Jackson's Point Harbourfront

Redevelopment Plan

Option 1a

No Realignment of Property Boundaries
With Boat Launch
93m of Public Water's Edge (at Lake)
August 10, 2017

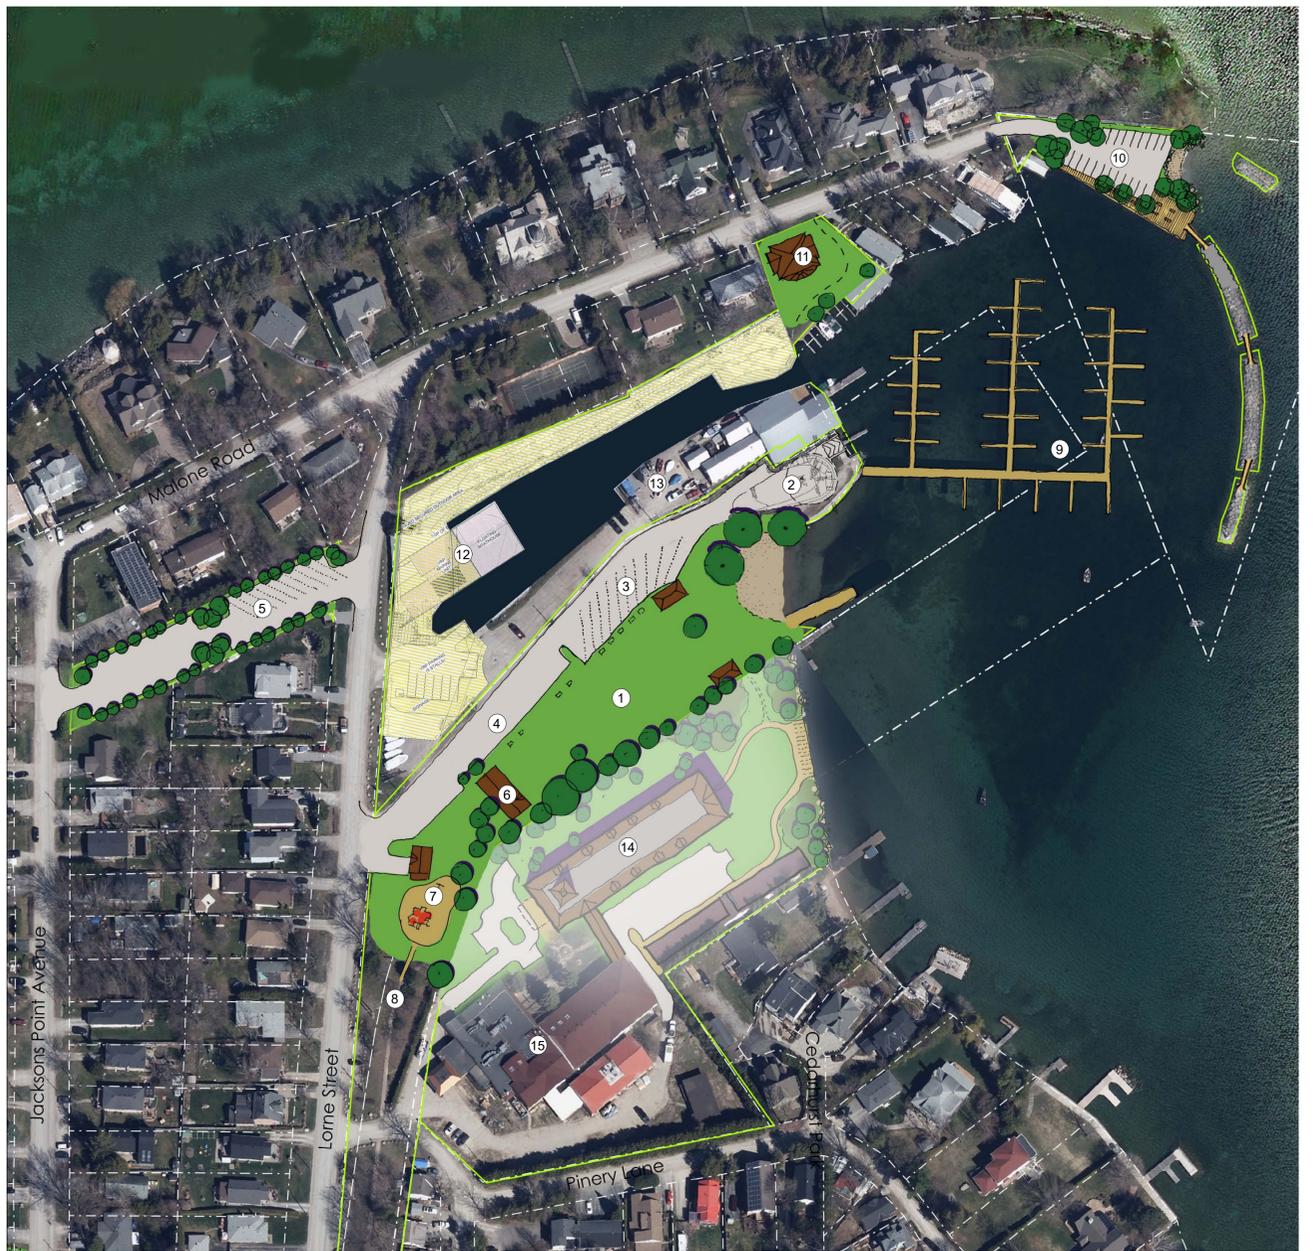
Note proximity of boat launch to beach could result in the removal of one or more mature trees, require fencing for safety, and result in loss of some slips.

This is the preferred concept

This concept is realistic

Maintain the linear park from Lake Drive

Malone Wharf upgrades are good, should have slips

Don't change the parking boundaries

Single family house or two singles on Malone Road is okay. The bylaw prohibits the roof line from being higher than Malone Road

Separate development on hotel property is good

Boat launch is good, add gas bar

Concern over water quality at beach due to lack of water flow caused by the spit and harbour

1a would be my choice due to washroom location and visual lines through the park

Option 1a is preferred, with a new boat launch and the playground maintained in the same location

The only plan that will work here is Option 1a. This park works well the way it is and most people want it to remain as is. Moving the playground is a safety hazard. Also any boardwalk along the channel is a waste of money

Plan 1a is the most appealing. Would suggest leaving the playground where it currently is and add a splashpad. The right of way (ROW) parking should be just for trailers, the rest should be residential and public parking

I like Plan 1a best, except for the wasted space at MSR/Lalu lands

Parallel parking the boats along the outer side of the 3rd arm would provide more safe passage

Trailer parking in the ROW lands is a no go. This is one of the few natural corridors to the lake left

Like the location of the boat launch and using the ROW for parking. Like the enhanced amenities at Malone Wharf. The park still needs fill to prevent flooding

...Towards a Preferred Plan Option 2a

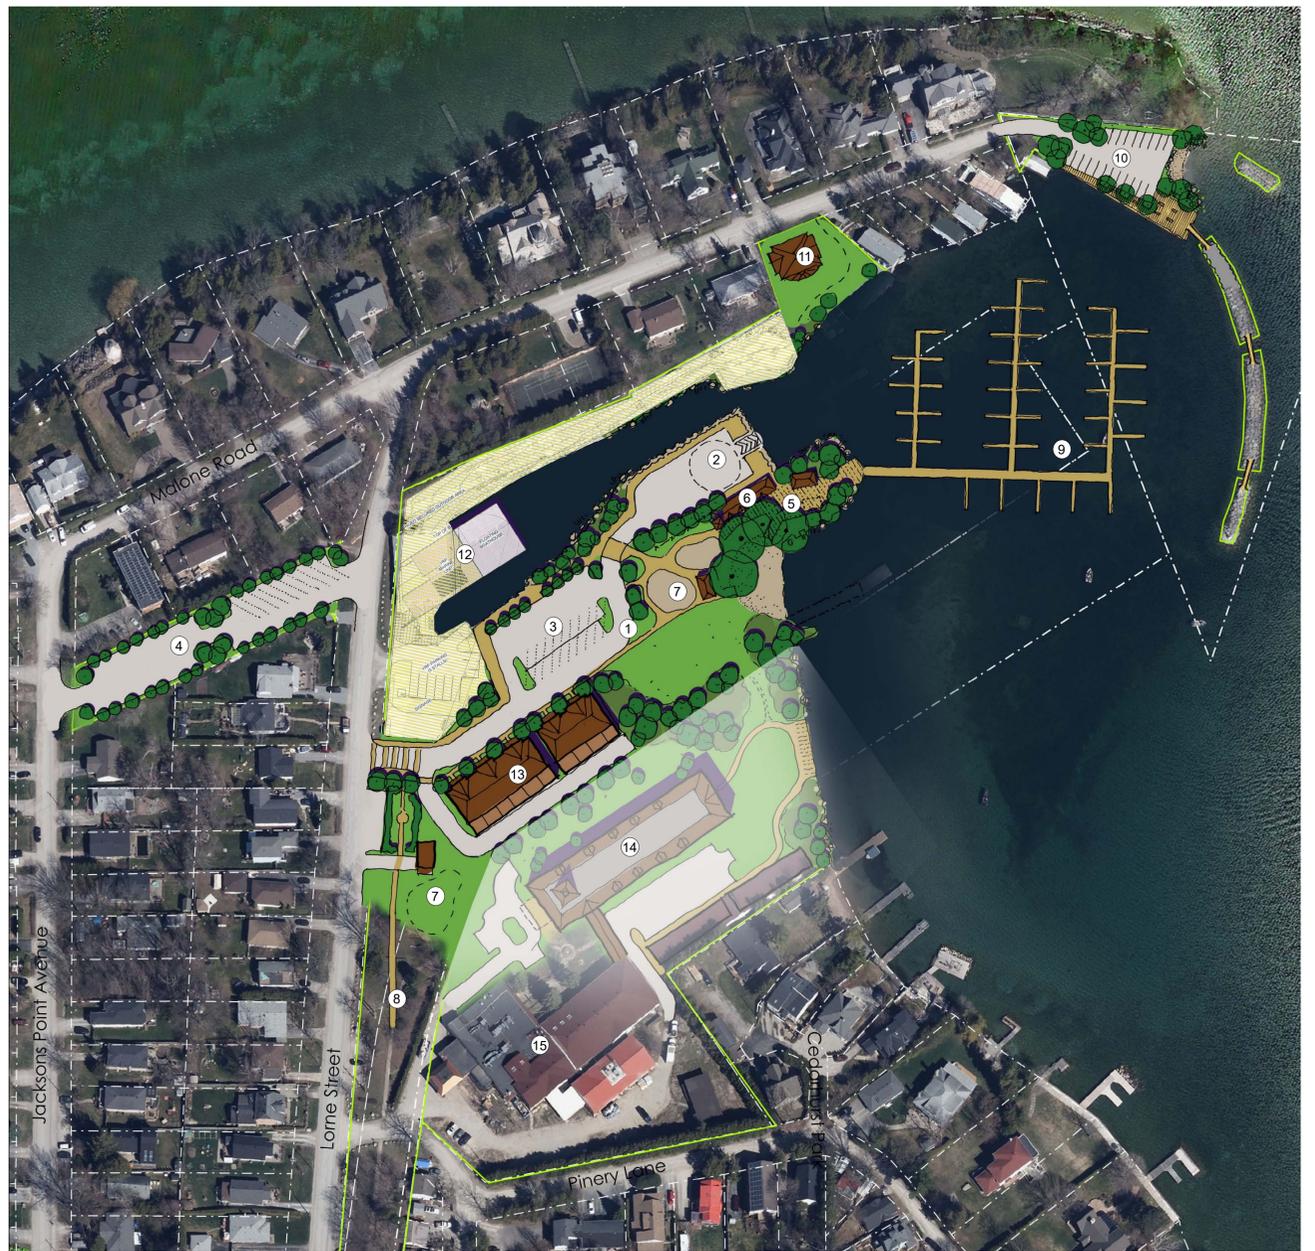
This gets my vote

Good concept if possible

You would get a boat launch and green space (but there is some concern about lost park space)

Malone Wharf is an underutilized asset, and is poorly maintained. Would like it enhanced with pedestrian lighting and a look out platform. Like the walkway along the spit

Ensure adequate parking for the residents of the new development

Add more trailer spots in the easement

Have a crosswalk from the parking easement to the park

Add green space and reduce the size of the parking spaces in the park area

Entry doesn't seem welcoming

There is too much asphalt

Stormwater concerns regarding the paved parking area in the easement

Emerging option 2a (with the boat launch) is the best out of the ones presented. Option 1a (with boat launch) is the second best if land exchanges cannot happen

The current design of the boat launch makes the turn into the launch quite tight. The tight space will cause issues with traffic and potential collisions. If it can be located in another location, it would minimize noise and pollution in the harbour. Maybe a location down by Kennedy Road or De LaSalle

provide enough room for truck turnaround. A longbox truck with a boat is 50 - 60 ft long. The current plans have a turnaround with 45-50 ft diameters. Boat trailers also have wheels near the back making them less maneuverable
No to Option 2. Interesting that MSR held the isolated pie shaped property bordering Lorne Street, Bonnie Boulevard and YRP Marine Unit as it certainly plays a major role in new development (Option 2) on park land

The boat launch will be very difficult to use, and parking will probably be used primarily by condo dwellers

Like the location of the boat launch. Concerned about liability if channel property is contaminated. Like ROW used for parking and the enhanced amenities at Malone wharf. Park needs fill to prevent flooding. Concerned about height of residential development. Like the public gathering area and the new washroom building

We note that in Emerging Option 2 the swimming dock has disappeared but there is no mention of the removal on the plan

Leaning towards option 2a. Boat launch area and accompanying parking sites should be designated for winter angler access
